**CITY OF TEMPE
DEVELOPMENT REVIEW COMMISSION**

**Meeting Date: 08/12/2014
Agenda Item: 2**

ACTION: Request for a Development Plan Review consisting of a new 2,961 s.f. restaurant with drive-through for POPEYE’S LOUISIANA KITCHEN, located at 1615 West Elliot Road. The applicant is SBL Engineering LLC.

DPR14117 Development Plan Review including site plan, building elevations, and landscape plan.

SITE PLAN
SP1
1 of 2

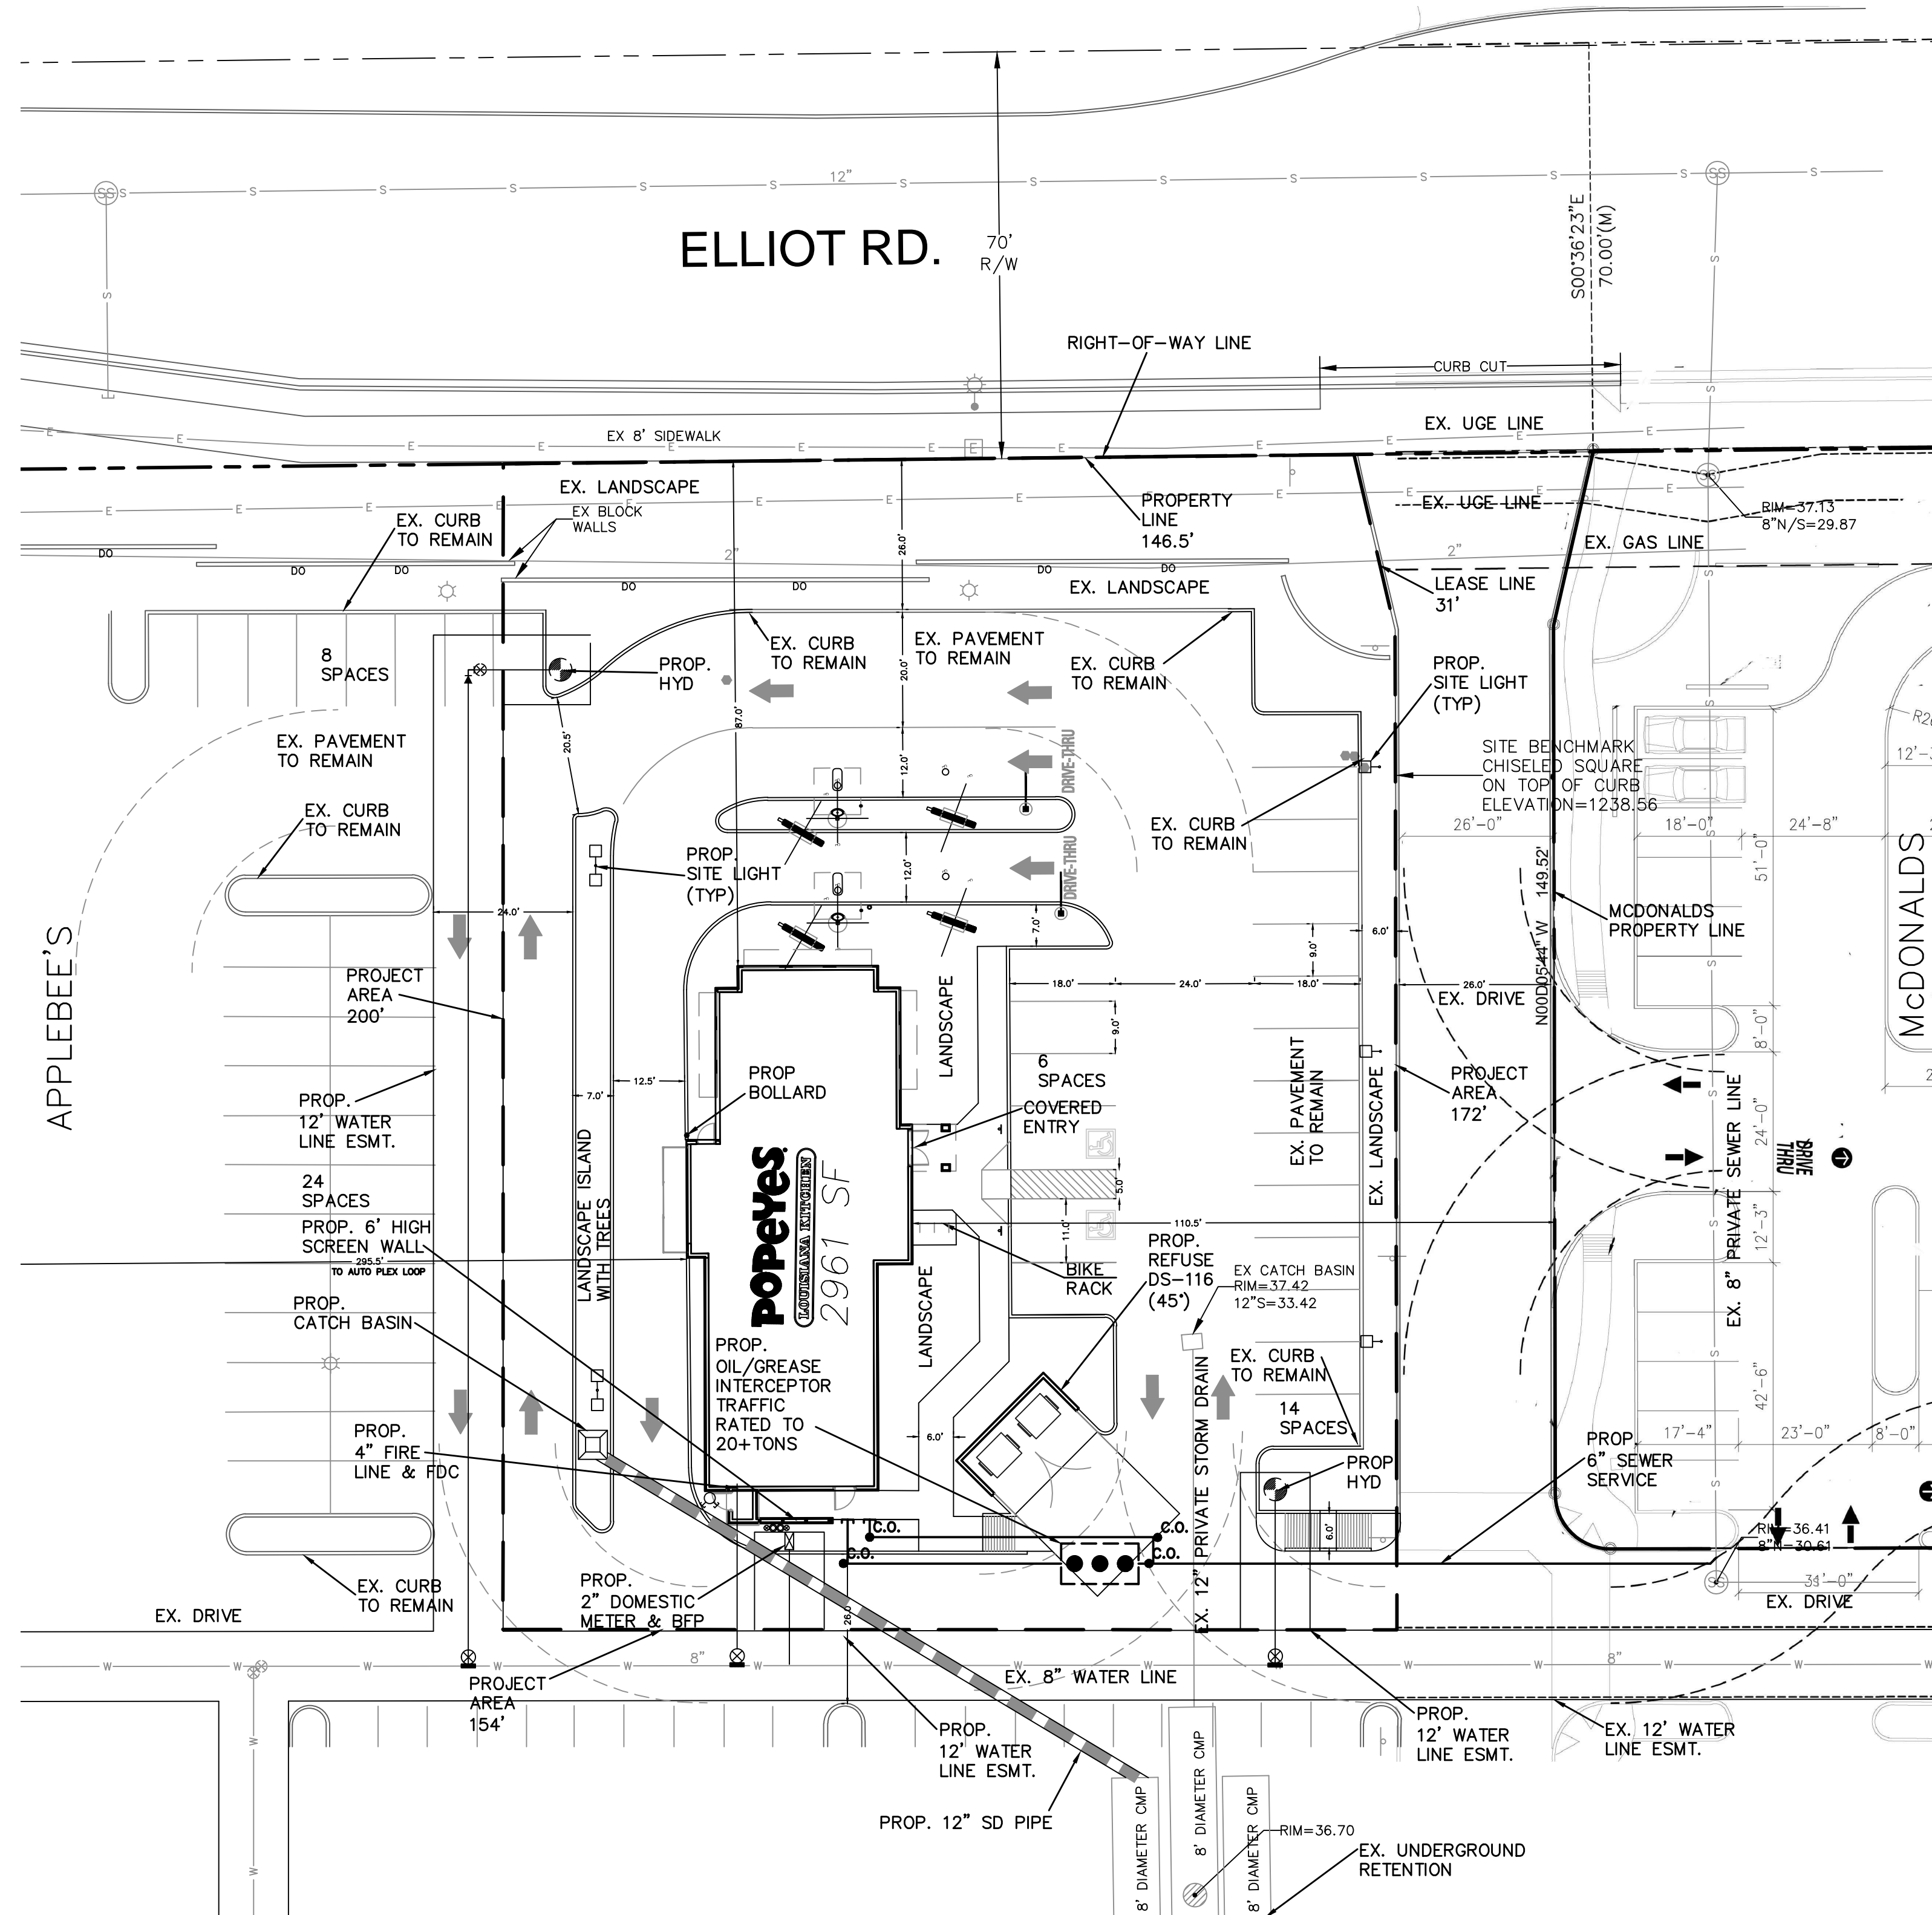
1. Provide service yard and mechanical (cooling tower/generator) yard walls that are at least 8'-0" tall as measured from adjacent grade and are at least the height of the equipment being enclosed, whichever is greater. Verify height of equipment and mounting base to ensure that wall height is adequate to fully screen the equipment. Locate electrical service entrance sections inside the service yard, as indicated.

2. Provide gates of steel vertical picket, steel mesh, steel panel or similar construction. Where a gate has a screen function and is completely opaque, provide vision portals for visual surveillance. Provide gates of height that match that of the adjacent enclosure walls. Review gate hardware with Building Safety and Fire staff and design gate to resolve lock and emergency ingress/egress features that may be required.

4. Place exterior, freestanding reduced pressure and double check backflow assemblies in pre-manufactured, pre-finished, lockable cages (one assembly per cage). If backflow prevention or similar device is for a 3" or greater water line, delete cage and provide a masonry or concrete screen wall following the requirements of Standard Detail T-214.
